January 17, 2023

Ref. T0967.02

Re: Apple Street Roadbed Elevation and Culvert Replacement Project; Essex, MA

Stone Walls:

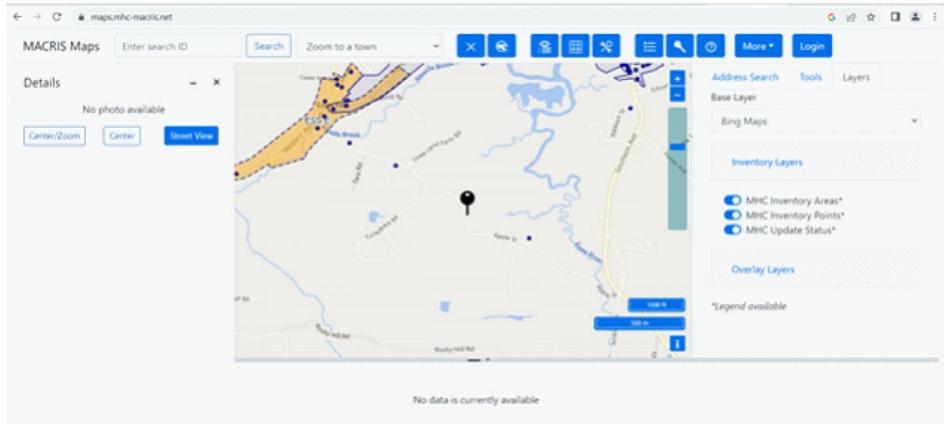
- We intend to include both in our plans and special provisions, details, and requirements for identifying, photographing, cataloging, stockpiling, and reconstructing existing stone walls that are to be removed and rebuilt as part of the project. Our goal is to continue to make the stone walls visible from the roadway to the greatest extent practical.
- The embankment construction will need to follow a particular material specification based on MassDOT requirements including the size and gradation of the stones to be used to ensure that the slope is stable. We will include in our special provisions requirements to reuse the native stones provided they meet specifications, or else provide a local similar conforming.
